Bayside Planning Panel

Item No	5.4
Application Type	Development Application
Application Number	DA-2015/272
Lodgement Date	30 January 2015
Property	369E Bexley Road, Bexley
Owner	Bayside Council
Applicant	Van Janevski
Proposal	Change of use of two (2) of the four (4) existing tennis courts to two (2) mini football fields/multi-purpose sports fields (including field lighting), conversion of one (1) tennis court to car parking to provide a total of 38 off-street parking spaces, convert existing brick structure to kiosk/office and signage to heritage item (former quarry) - the remaining tennis court will be used as a sitting / waiting area.
No. of Submissions	The latest notification attracted six (6) written letters of objection, plus a petition containing thirteen (13) signatures also objecting to the proposal.
Cost of Development	\$400,000
Report by	Creative Planning Solutions

Planning Assessment Report

Application Number:	DA-2015/272
Date of Receipt:	30 January 2015
Property:	369 E Bexley Road BEXLEY NSW 2207
Owner:	Bayside Council
Applicant:	Golden Goal Pty Ltd
Proposal:	Change of use of two (2) of the four (4) existing tennis courts to two (2) mini football fields/multi-purpose

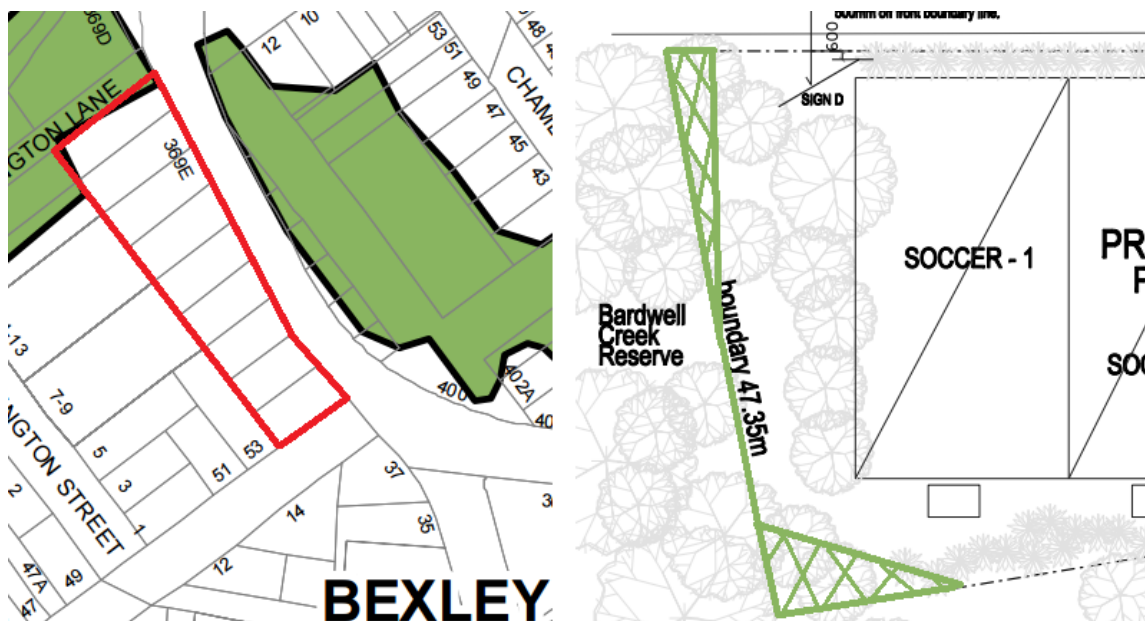
It is noted that a small portion of the subject site in the northern corner is identified as 'Biodiversity' on the Terrestrial Biodiversity Map. However as noted in the **Figure 7** below, this is not land affected by works associated with the proposed development as the light poles and courts to be modified are positioned to the south of this biodiversity land.

Figure 8: This diagram shows the distance from the proposed development (i.e. light poles) to Bardwell Creek, which is classified as a watercourse by Rockdale City Council.

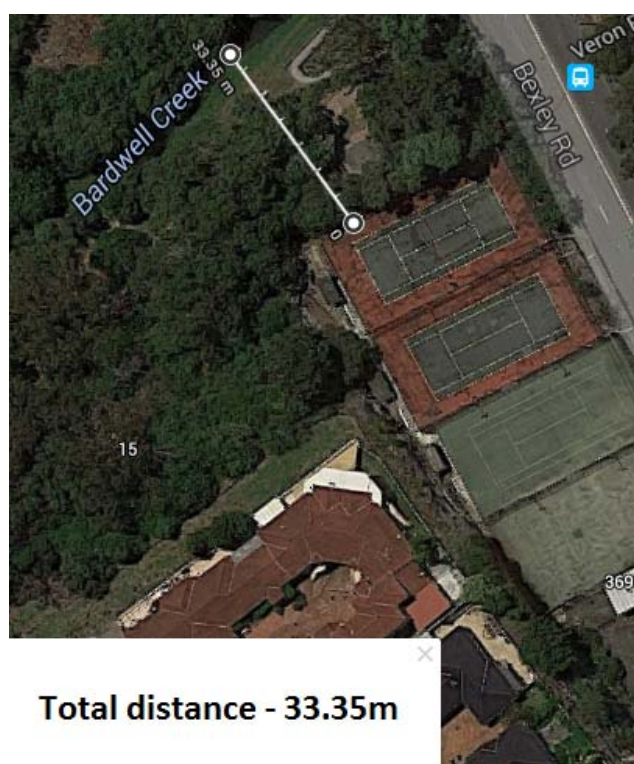
Refer to **Figure 8** below for the location of the light poles to the aforementioned watercourse.

As mentioned, many facets of the proposal will involve minimal works that would unlikely cause any significant impact to the adjacent watercourse. This is because the proposal relates principally to the change of use of the tennis courts to multi-purposes sports, new light poles anchored to existing footings. The adaptive reuse of an existing building for the kiosk, and formalisation of an existing car park would be located further than 40m from the watercourse.

Having regard to the above, the proposal is therefore considered acceptable when having regard to the provisions of clause 6.9 of LEP2011.
